OUR TOWN HALL PROJECT

PROJECT STATUS	RIBA Stage 5
CLIENT	Manchester City Council
PROJECT	Our Town Hall
DRAWING TITLE	Chimney Number CS26 Proposed repairs
SIZE & SCALE	A2: As indicated
DRAWING STATUS	S4 - Construction

JOB NUMBER	236959	
DRAWING NO.	OTH-PUR-TH-RF-DWG-A-4186 05	REV

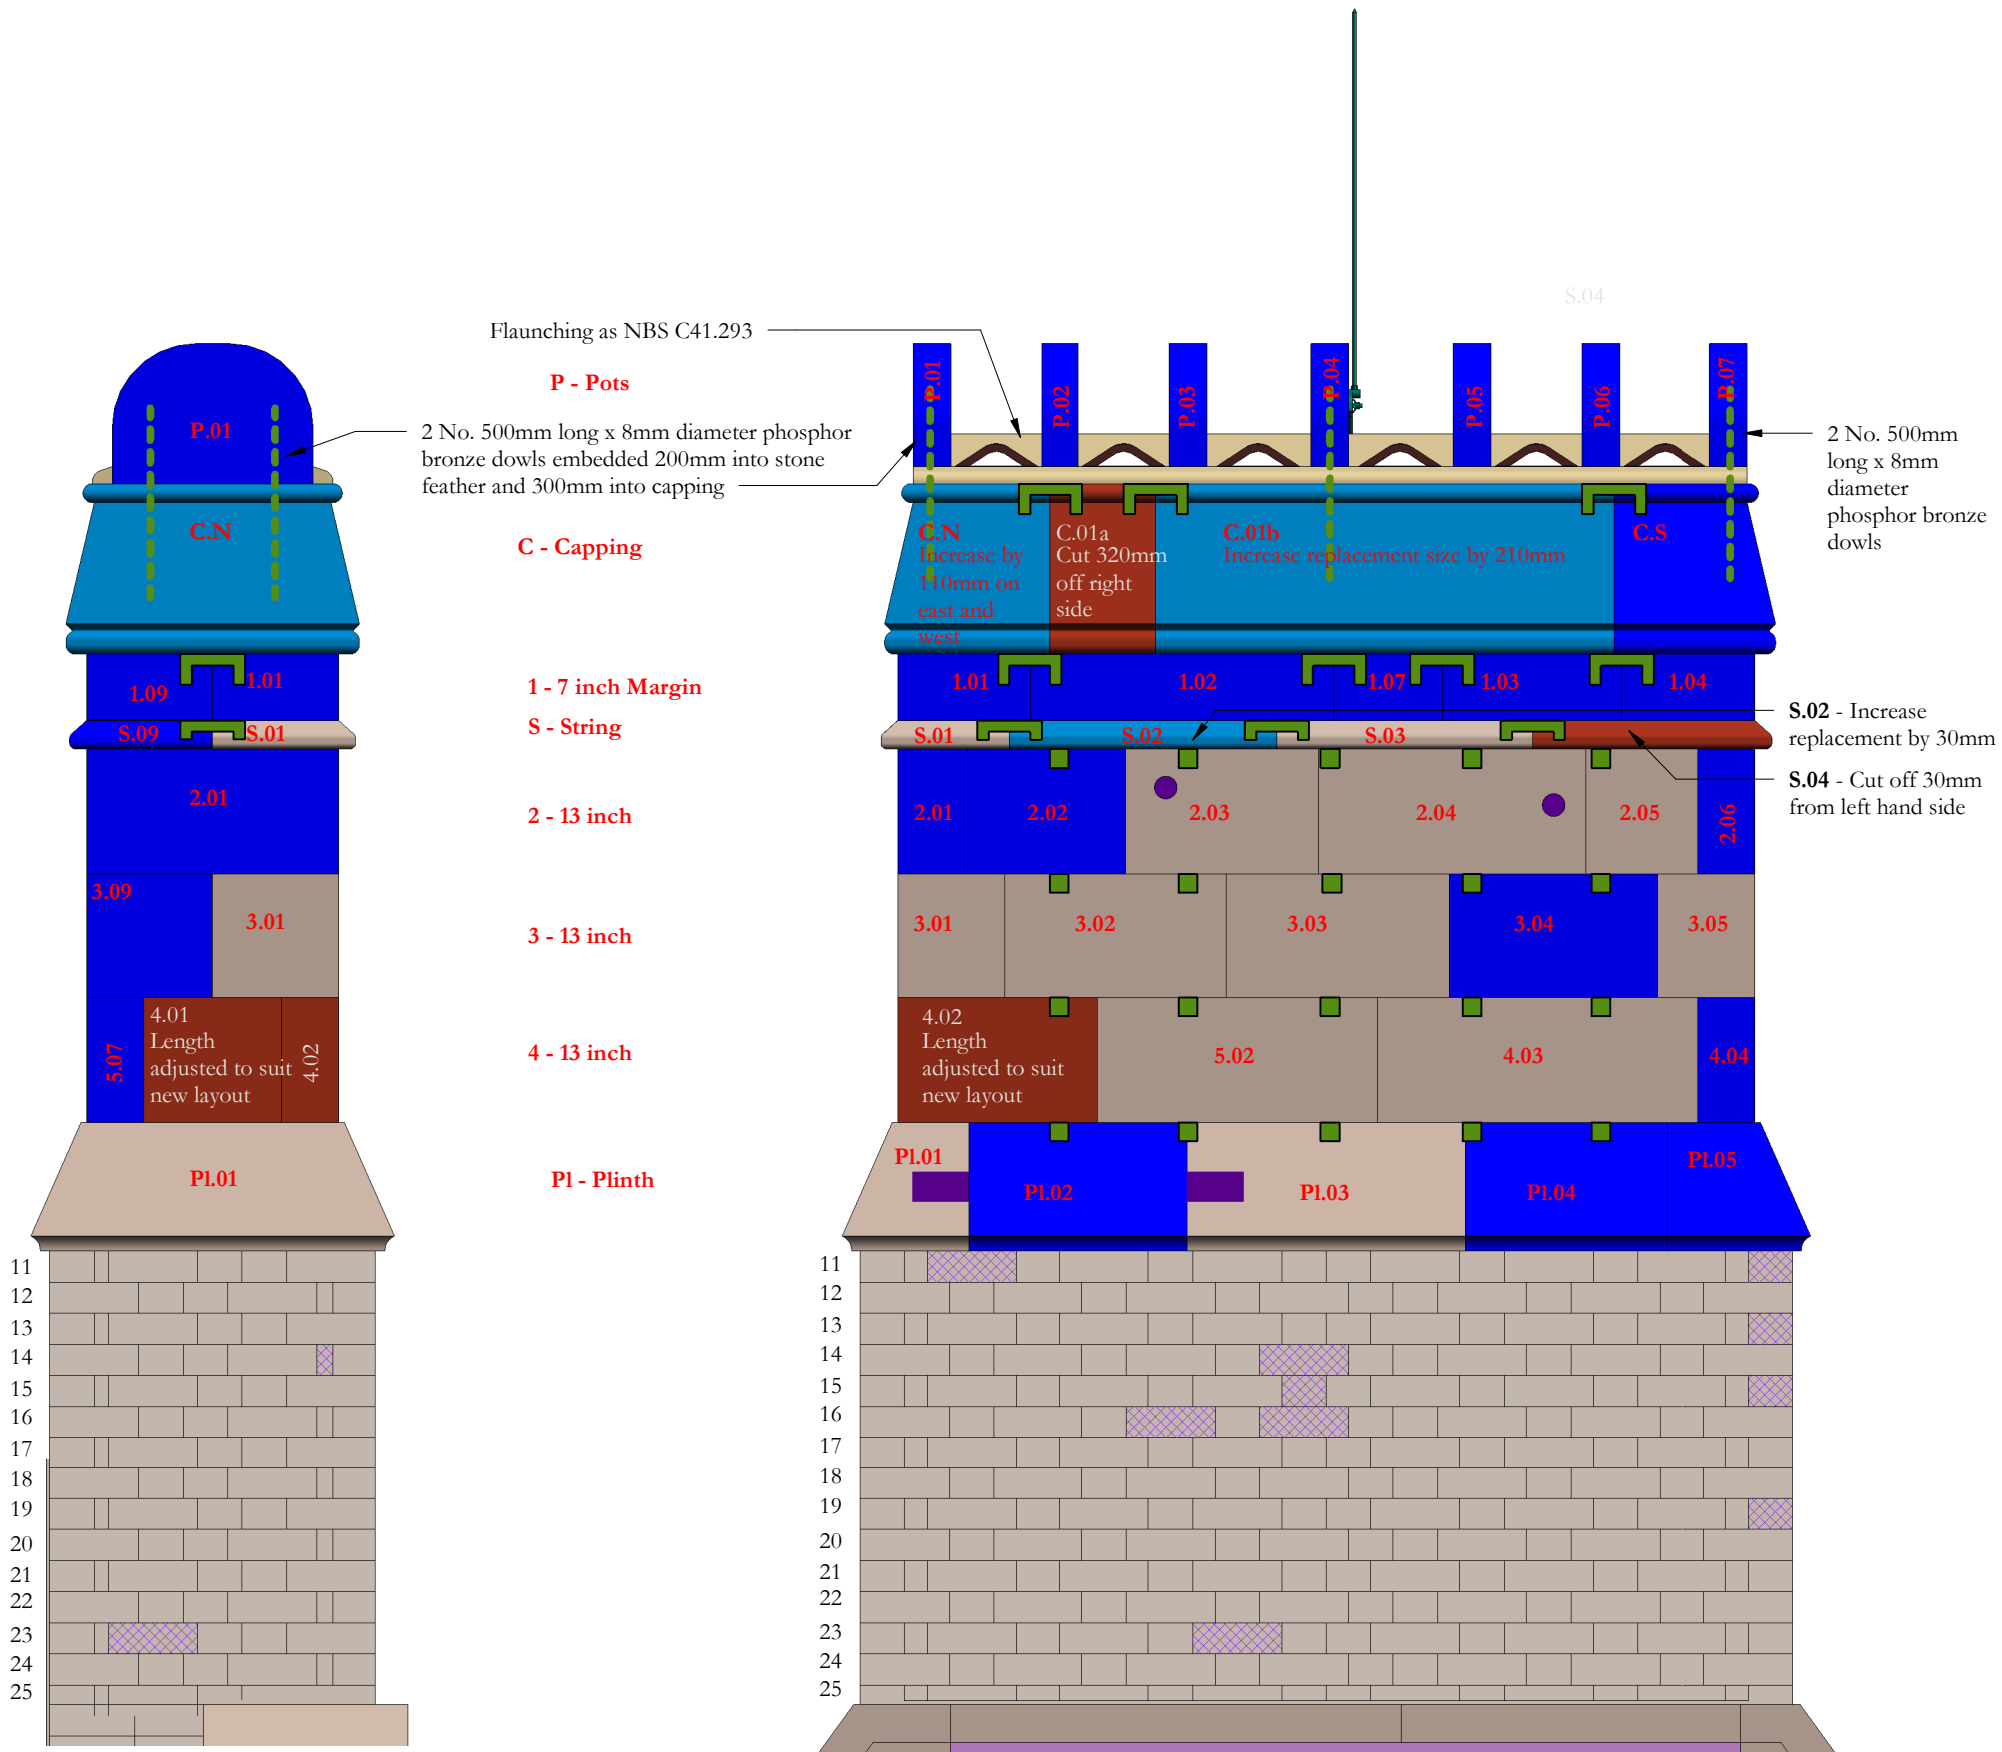
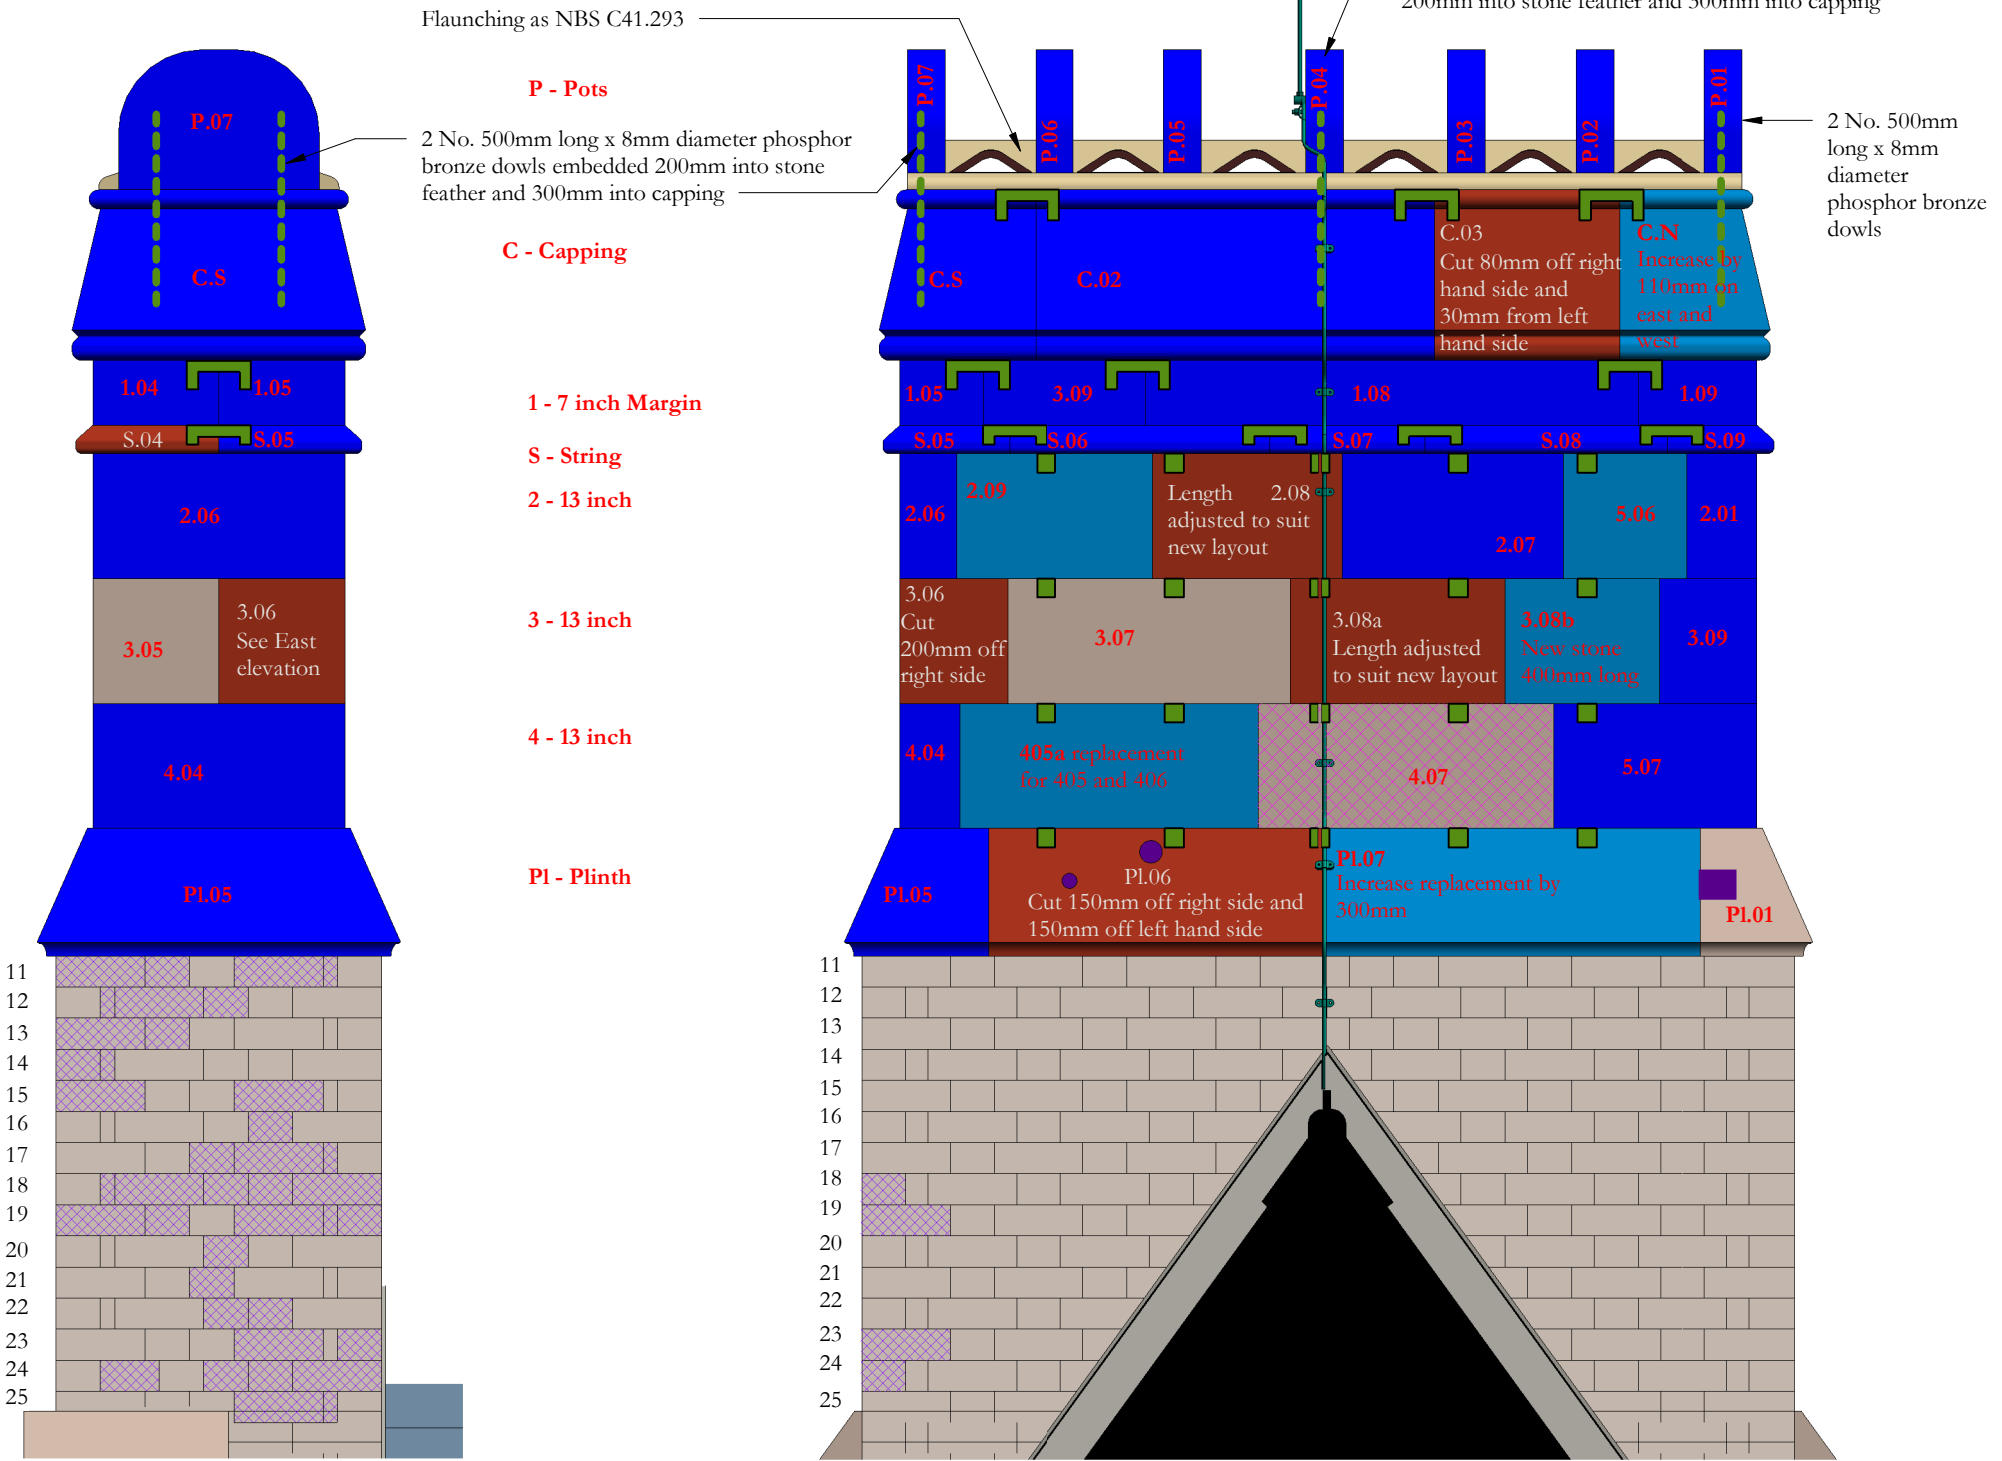
Revision 02
C.S, C.02, S.07, S.08, 3.09, 4.04, 5.01, 5.06 PL.05 all changed to like for like replacement. C.N. changed to 110mm increase on east and west, C.03 altered to remove 80mm from RHS and 30mm from LHS. Add 30mm to S.02, remove 30mm from S.04, 200mm cut from RHS of 3.08a, new 400mm stone 3.08b added. Additional 150mm cut from LHS of PL.06 and replacement P.07 increased in size to 300mm

Revision 03
Lightning protection added. Bronze cramps added across feathers and bronze dowels added to stone feather references P01, P04 and P7

Revision 04
Height of chimney lowered by 10 brick courses and 1 ashlar course. Ashlar stones 5.02, 5.06, 5.07, 2.07, 2.08 and 2.09 relocated to ensure offset perp joints in ashlar stone following reduction in height. Length of existing ashlar stones 2.08, 3.08a, 4.01 and 4.02 to be adjusted to suit new stone arrangement

Revision 05
West side: Length of 1.01 reduced to allow joint between 1.01 and 1.02 to be mid-way between joints in copings above and joints in string course below. Stone 1.02 moved north and 1.07 moved between 1.02 and 1.03. Stones 1.02 and 1.03 reduced in length to move the perp joint at the south end of 1.02 to 150mm from the joint on the north end of S.03 East side: Length of 1.05 reduced to 221mm. Stone 3.09 used in place of stone 1.07 between 1.05 and 1.08
